APPLICATION FOR A MAJOR SITE PLAN REVIEW

APPLICATION #: SPR26-0030
APPLICANT: Douglas Glover (representative)
OWNER: Bohl Enterprises LTD
ADDRESS: 5315 Stickney Avenue
PARCEL(S): 22-07040
ZONING: General Industrial (IG)
NEIGHBORHOOD: Industrial North
REPORT DATE: July 31, 2026
HEARING DATE: August 13, 2026
STAFF REVIEWER: Vachon

The request is for a new Manufacturing Facility with adjoining parking lot to be located at 5315 Stickney Avenue. The proposal is a greenfield development.

Proposed Site Plan.

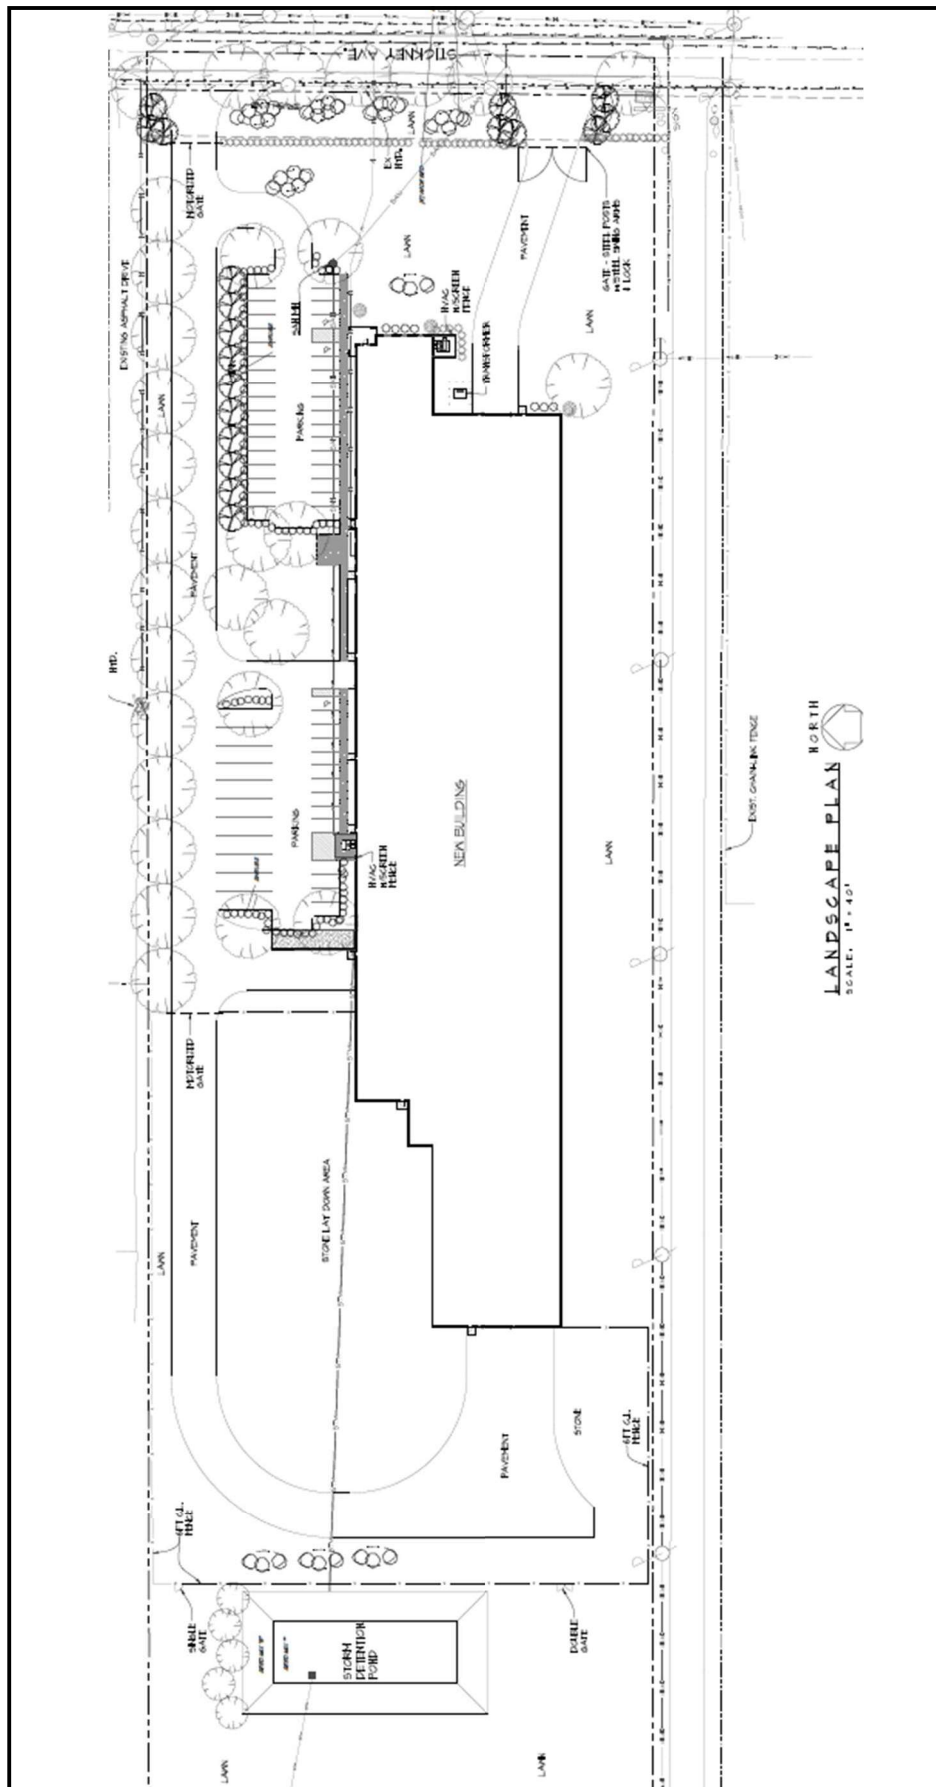
- (a) *Bicycle Parking (1107.0900)*. A minimum of one (1) bicycle parking space for every ten (10) vehicle parking spaces is required. – Not acceptable as depicted. The applicant shall submit a revised site plan.
- (b) *Wheel Stops (1107.1907)*. Whenever a parking lot extends to a property line, sidewalk, planting strip, or building, a wheel stop device consisting of a concrete stop or curb shall be installed to prevent any part of a parked vehicle from overhanging onto walkways or landscaping. – Not clearly defined on site plan. Wheel stops or concrete curbing shall be provided wherever the parking lot extends onto a property line, sidewalk, building, and landscaping.

21. Accessible parking signs must be posted directly in front of the parking space at a height of no less than 60 inches and no more than 72 inches above pavement level per TMC§1107.1704.
22. Wheel stops are required at all parking spots abutting sidewalks, property lines, planting strips and buildings per TMC§1107.1907
23. Bicycle Parking is required per TMC§1107.0900.
24. Pedestrian Ramp shall be provided as needed for accessible parking to the adjacent sidewalk or entrance per TMC§1107.1705.
25. Sidewalk required along Stickney Avenue and connected to the building sidewalk.
26. The 18' drive aisle shall be 25' per TMC§1107.1911

27. A minimum of one (1) bicycle parking space for every ten (10) vehicle parking spaces shall be provided.
28. Pursuant to TMC§1108.0500, a landscape plan identifying the location, number, height, diameter and species of any materials to remain or be planted shall be provided. Trees, shrubs, and landscape materials must meet the Landscape Material Standards listed in TMC§1108.0400. The landscape plan shall also include:
 - a. Foundation plantings along the south elevation of the building.
 - b. Applicable irrigation or xeriscaping plans.
 - c. Dumpster(s) shall be screened on all four sides with a six-foot tall fence, if applicable.
 - d. Pursuant to TMC§1108.0203(H), all outdoor storage shall be screened.

Proposed Landscape Plan.

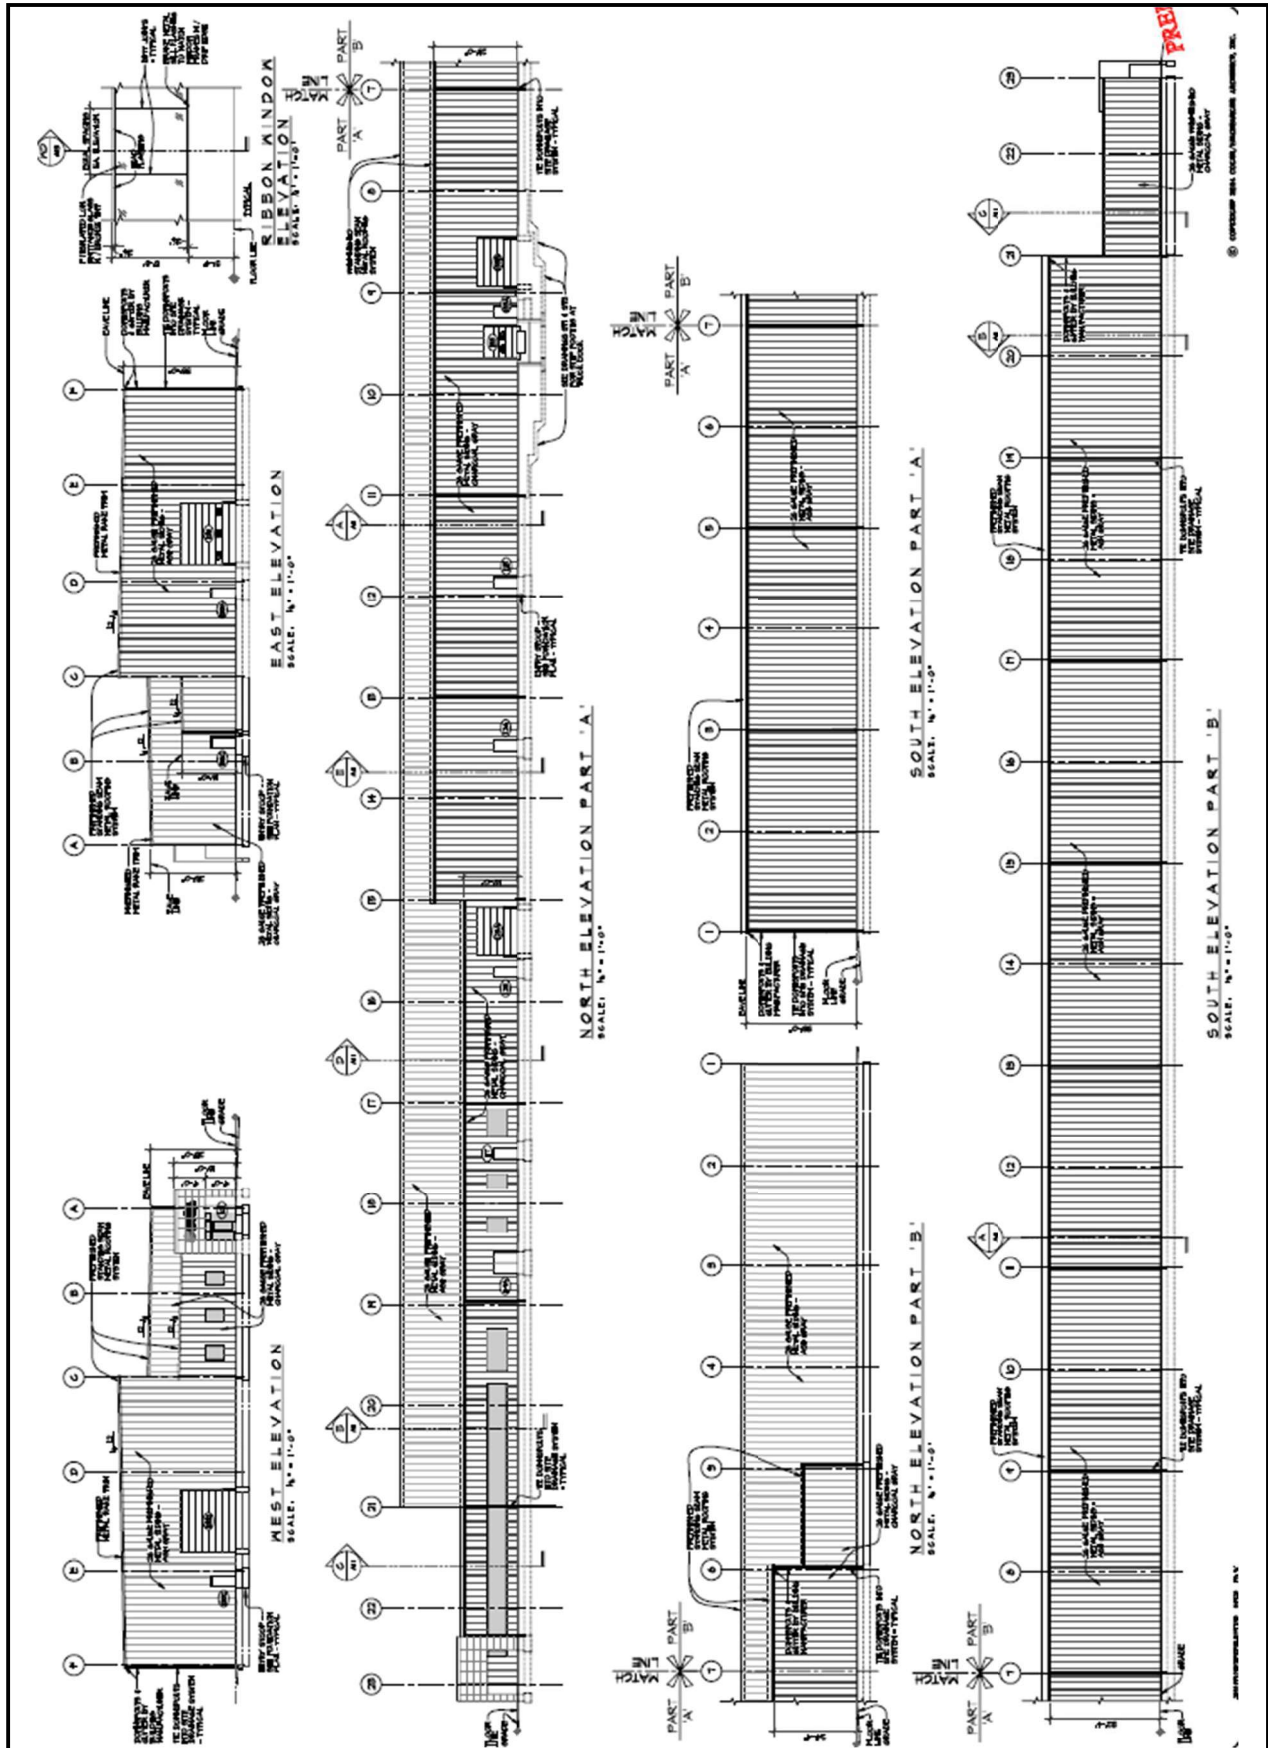
- (a) *Interior Site Landscaping (1108.0205)*. Foundation plantings along all portions of the building that are visible from public street rights-of-way are required. – Not acceptable as depicted, a revised landscape plan shall be provided depicting foundation plantings along the south elevation of the building.

- (b) *Irrigation/Watering (1108.0406)*. Landscaped areas must be irrigated as necessary to maintain required plant materials in good and healthy condition. All landscaped areas shall be provided with a readily available water supply. Water outlets (hose bibbs) shall be provided within 100 feet of all required plant material unless a subsurface irrigation system is used. Plantings may be further than 100 feet from water outlets in areas where sufficient xeriscaping is used. – Not depicted, applicable irrigation or xeriscaping plan shall be provided for review and approval.

- (c) *Landscape Plan (1108.0500)*. A landscape plan identifying the location, number, height, diameter and species of any materials to remain or be planted shall be provided. Trees, shrubs, and landscape materials must meet the Landscape Material Standards listed in TMC§1108.0400. – Not acceptable, the submitted landscape plan does not identify the species of materials, a revised landscape plan shall be submitted.

Proposed building elevations.

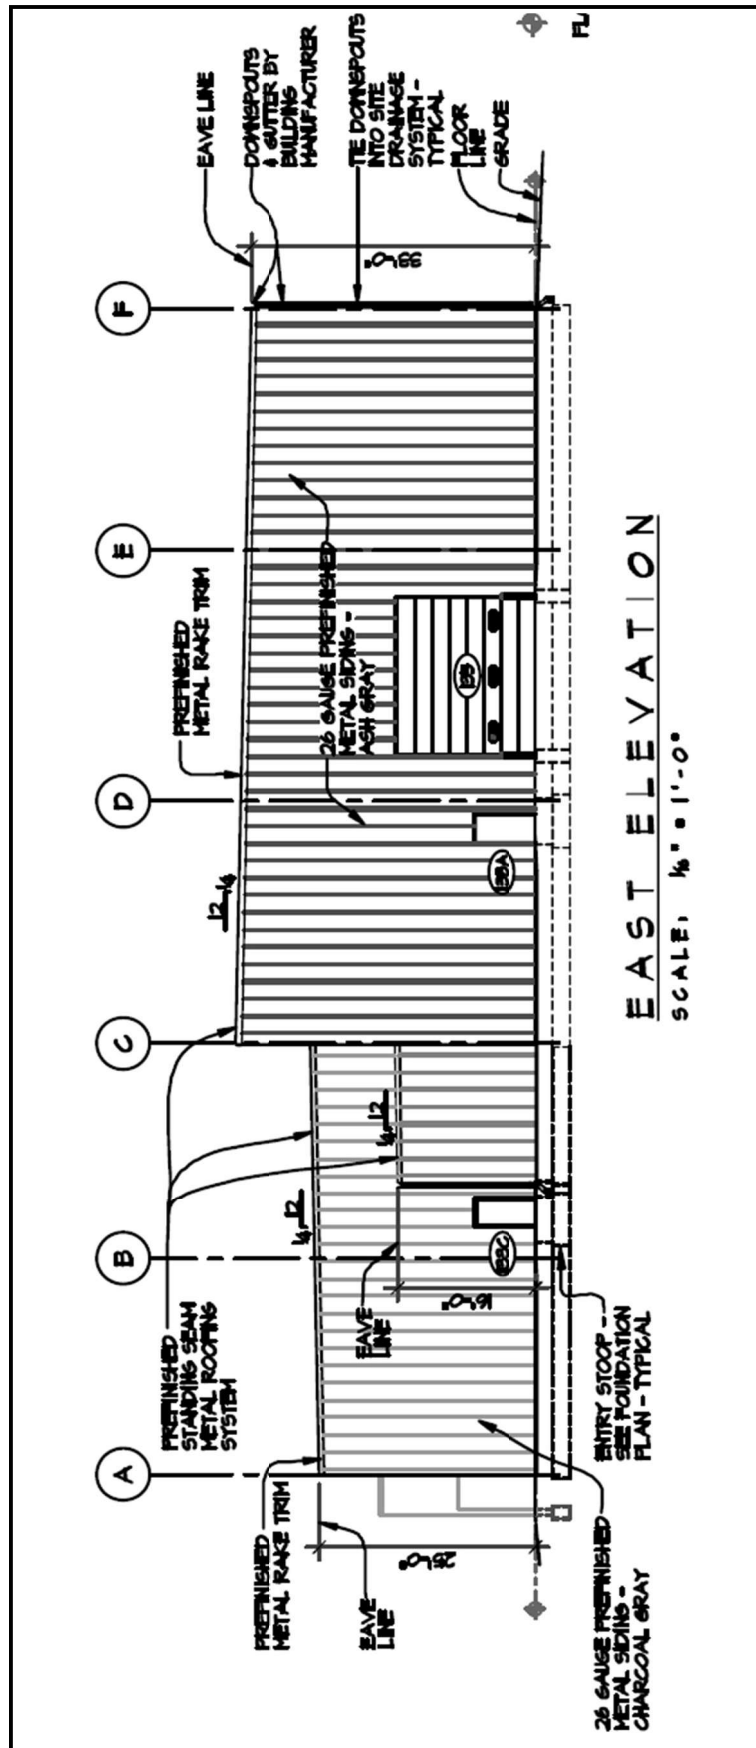
- (a) *Industrial Building Design Standards (1109.0401)*. Along major streets, buildings shall be sited so that at least thirty-percent (30%) of the building frontage shall not consist of a blank wall. – Not acceptable as depicted. A change in material such as windows, wainscoting, columns, or other approved design shall be provided on the east elevation.

29. The building shall be sited so that at least thirty-percent (30%) of the building frontage (east facade) does not consist of a blank wall. Revised elevations shall be provided for review and approval.
